Bridge Replacement
BRF-071-4(57)--38-05

Bridge Replacement

Stream 0.6 Mi N of I-80

D2 VIRTUAL FIELD EXAM
June 27, 2023

STAGE 1
14'-6" CLEARANCE
(TC-217)
INSTALL TEMP PAVING PRIOR TO STAGE 1

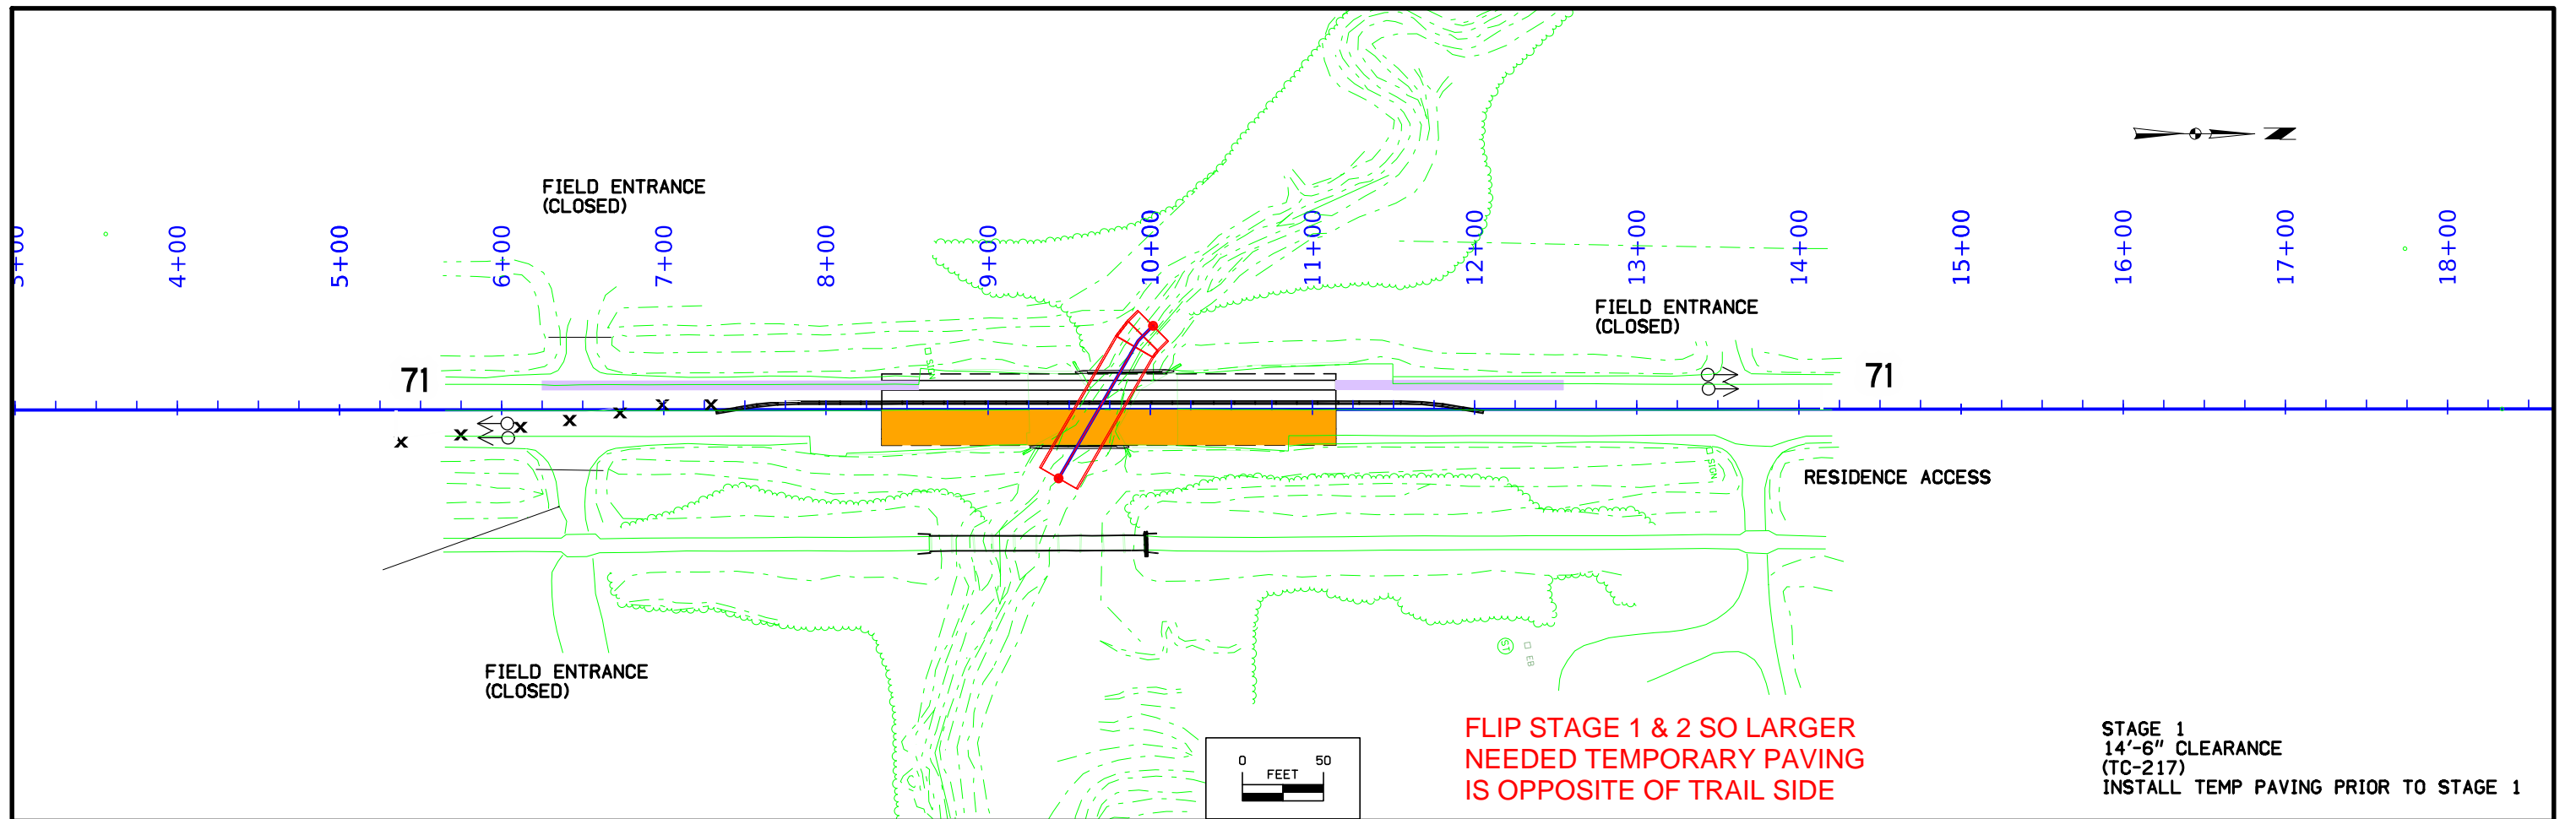
FLIP STAGE 1 & 2 SO LARGER
NEEDED TEMPORARY PAVING
IS OPPOSITE OF TRAIL SIDE

UPDATE SHADING TO
REFLECT WHAT IS BEING
CONSTRUCTED.

STAGE 2
 12'-0" CLEARANCE
 (TC-217)

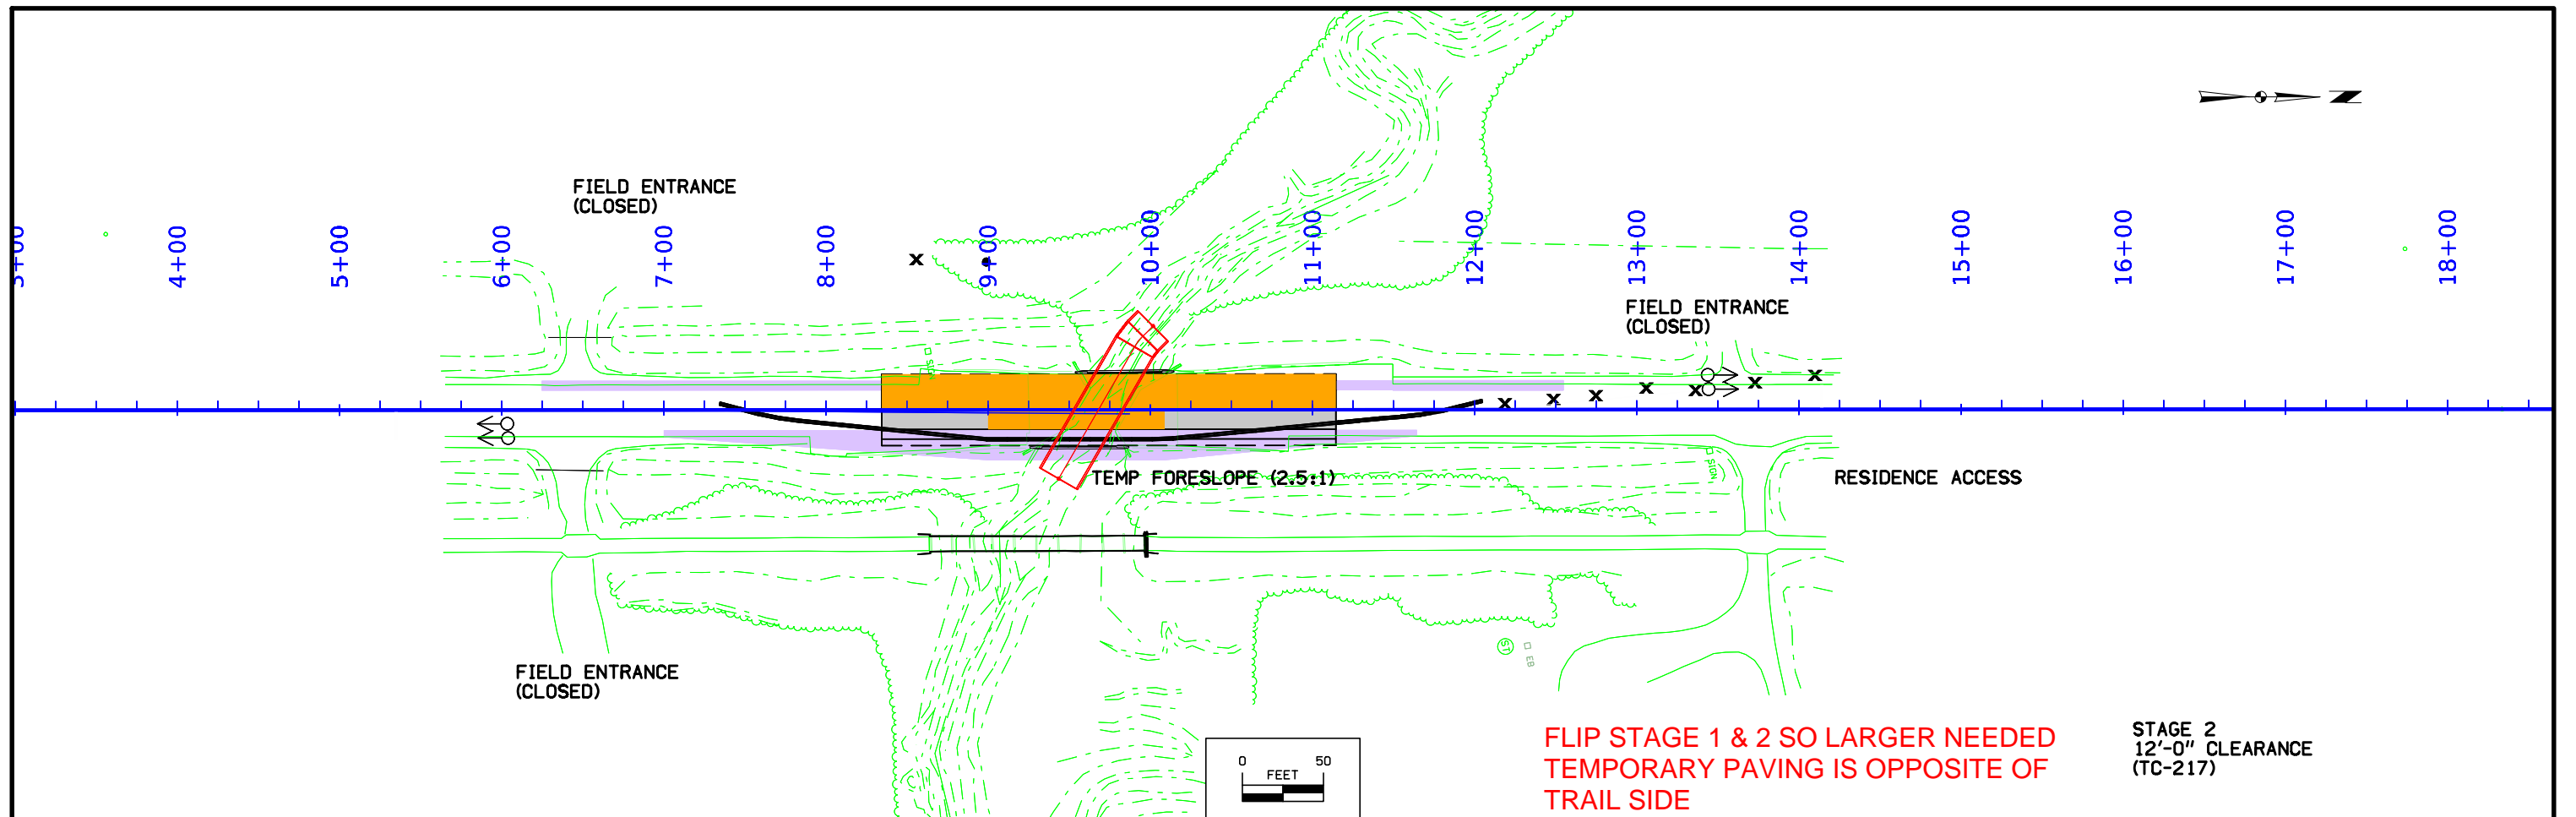
FLIP STAGE 1 & 2 SO LARGER NEEDED
 TEMPORARY PAVING IS OPPOSITE OF
 TRAIL SIDE

UPDATE SHADING TO REFLECT WHAT IS
 BEING CONSTRUCTED.

IF SLOPE OF 2.5:1 IS NEEDED, ADD TBR
 TO PROTECT SLOPE.

ADD STAGING TYPICAL SECTION

SITUATION PLAN

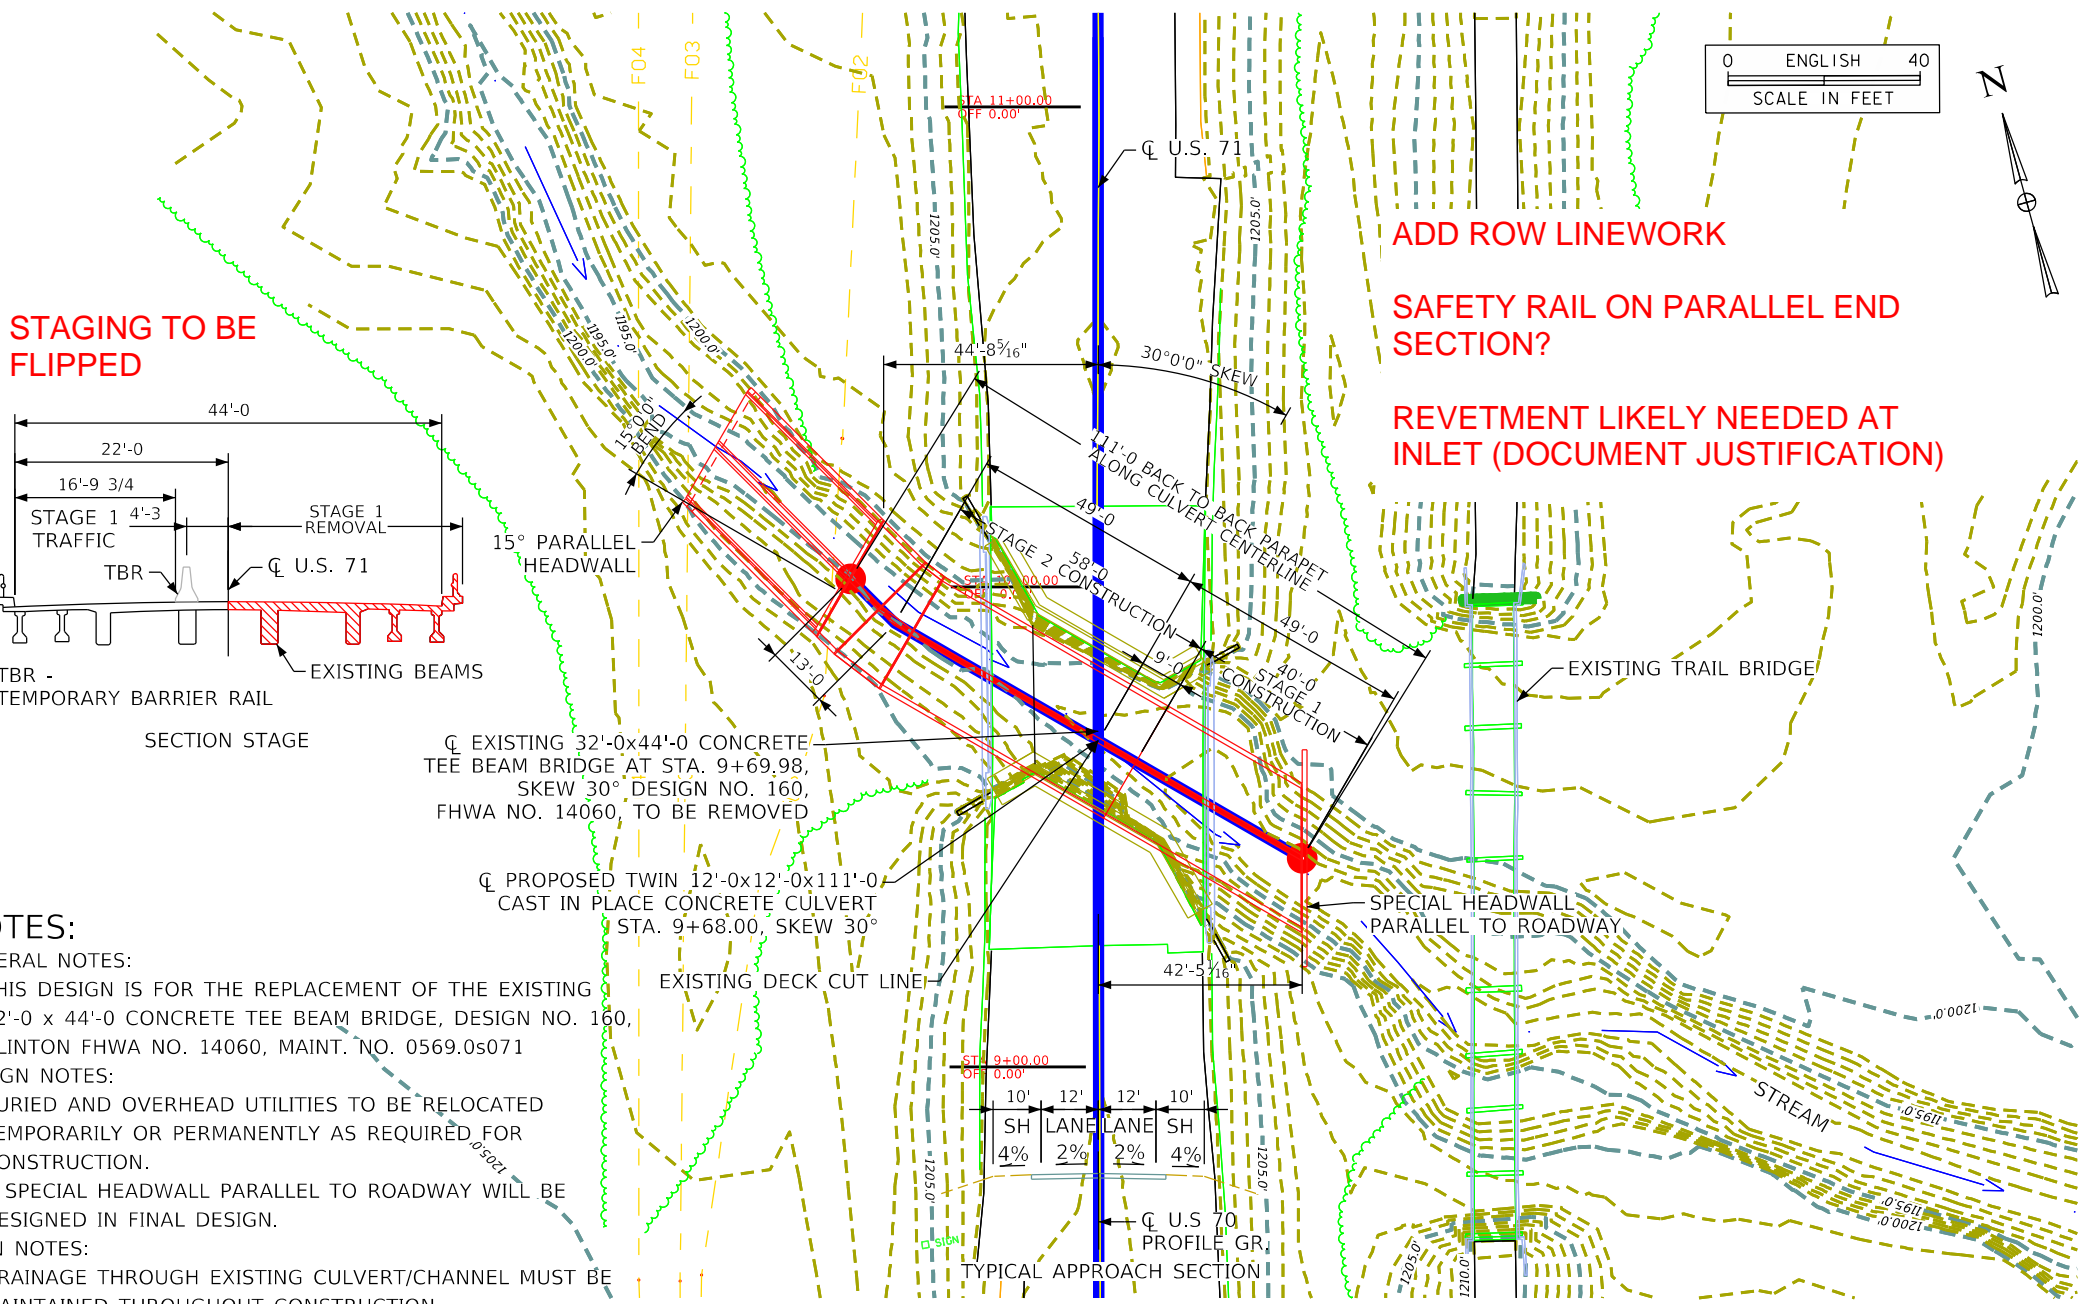
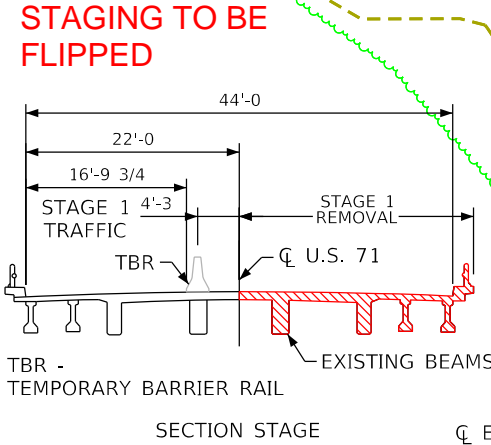
- ADD ROW LINEWORK
- SAFETY RAIL ON PARALLEL END SECTION?
- REVETMENT LIKELY NEEDED AT INLET (DOCUMENT JUSTIFICATION)
